10/812,408

Office Action Summary

KAMIYA, TOSHIYUKI

DETAILED ACTION

FIG.4F

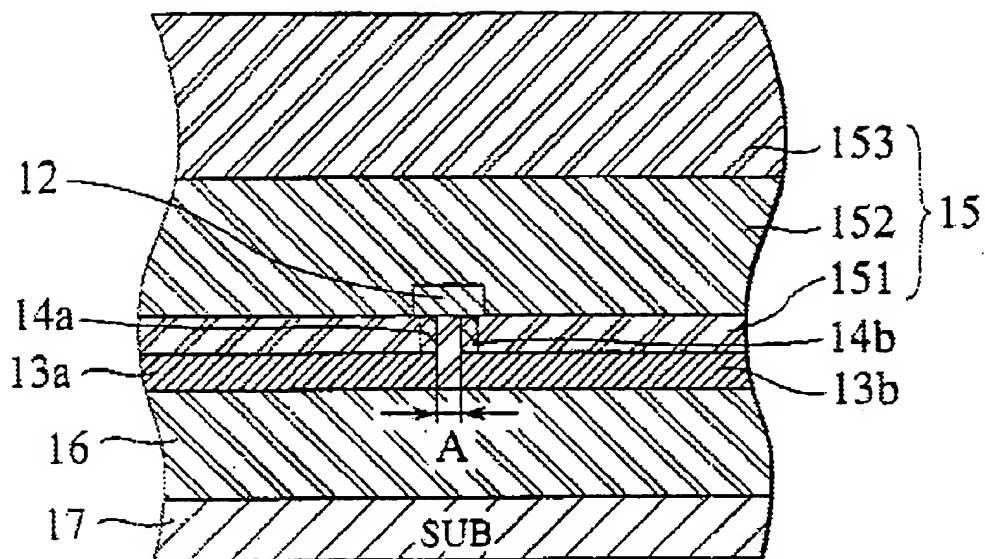
Regarding claim 1, Ohhashi (figures 4F-4G) discloses a semiconductor device comprising:

a second protection film 153 on the first protection film 152 (see figure 4F and column 10, lines 6-7), the second protection film 153 including an opening section 11 formed therein that exposes the first protection film 152 (see figure 4G and column 10, lines 13-15);

- a step of forming a fuse 12 including of an upper layer wiring layer on an upper surface of an interlayer dielectric layer 151 that is formed on a substrate 17 (see figure 4F and column 9, lines 44-46);

- a step of forming a second protection film 153 on an upper surface of the first protection film 152 (see figure 4F and column 10, lines 6-7); and

- a substrate 17 (column 6, line 23);
 - a fuse 12 disposed on the substrate 17, the fuse 12 including an upper layer wiring layer (see figure 4F and column 10, lines 1-4);
 - a first protection film 152 disposed on the fuse 12 (column 10, lines 1-4); and
 - a second protection film 153 disposed on the first protection film 152 (see figure 4F and column 10, lines 6-7), the second protection film 153 including an opening 11 formed therein that exposing the first protection film 152 (see figure 4G and column 10, lines 13-15);
- the opening section 11 having a width at least equal to a width of the fuse 12 (see figure 4G).

FIG.4G

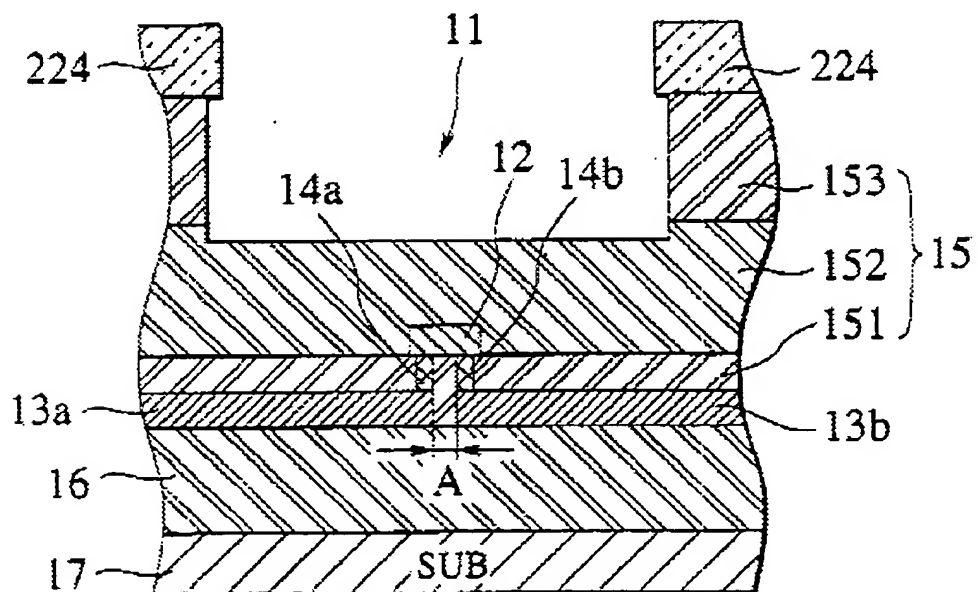
the opening section 11 exposing an entire portion of the first protection film 152 located directly above the fuse 12.

Regarding claim 2, Ohhashi (figure 4G) further discloses that each of two end sections of the fuse 12 is connected to a lower layer wiring layer (13a and 13b) through a via hole (14a and 14b) (also see figure 5A).

- a step of forming the opening section 11 in the second protection film 153, the opening section 11 that exposing an entire portion of the first protection film 152 located directly above the fuse 12 (see figure 4G and column 10, lines 13-15).

Regarding claim 4, Ohhashi (figure 4G) further discloses the steps of forming via holes (14a and 14b) in the interlayer dielectric layer 151, and connecting two ends of the fuse to a lower layer wiring layer (13a and 13b) through the via holes (14a and 14b) (also see figure 5A).

Regarding claims 6-7, Ohhashi further discloses that the opening section 11 extends outboard of the fuse 12 and the opening section 11 includes bottom end portions outboard of the fuse 12 (see figure 4G).
